N5241A-03

S E R V I C E

N O T E

N5241A PNA Series Microwave Network Analyzers

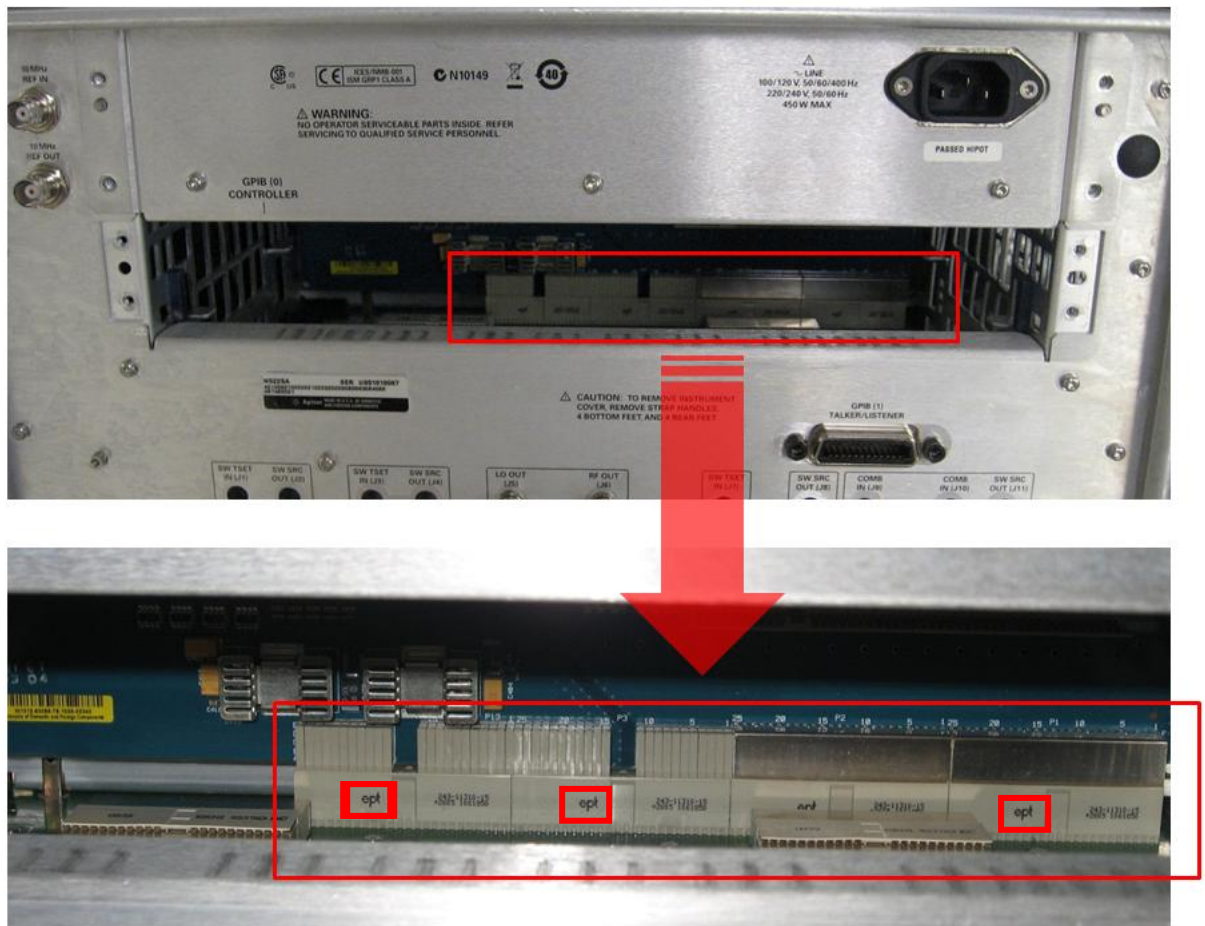
1. Remove the CPU assembly from the analyzer's rear panel. Refer to the PNA Service Guide chapter 7 section titled, "Removing and Replacing the CPU Board Assembly" for removal and reinstallation procedures. To view the online Service Guide, see the numbered list on the next page for instructions.
2. As per the photo below, inspect the system motherboard connector to see if it has one or more "ept" logos.

3. If the connector has one or more “ept” logos, return the analyzer to Agilent for replacement of the system motherboard. If the connector does not have one or more “ept” logos, email support_ctd-soco_support@agilent.com, providing the analyzer model and serial number and details of the malfunction symptoms.

4. *For Agilent Service Technicians only:* Only new boards without “ept” logos should be installed. Before installing the new board, look to see if it has one or more “ept” logos. If so, email support_ctd-soco_support@agilent.com, providing the analyzer model and serial number. Wait for further instructions in an email reply. New boards without “ept” logos can be installed.
For installation instructions, refer to the PNA Service Guide chapter 7 section titled, “Removing and Replacing the System Motherboard.” To view the online Service Guide, see the numbered list on the next page for instructions.
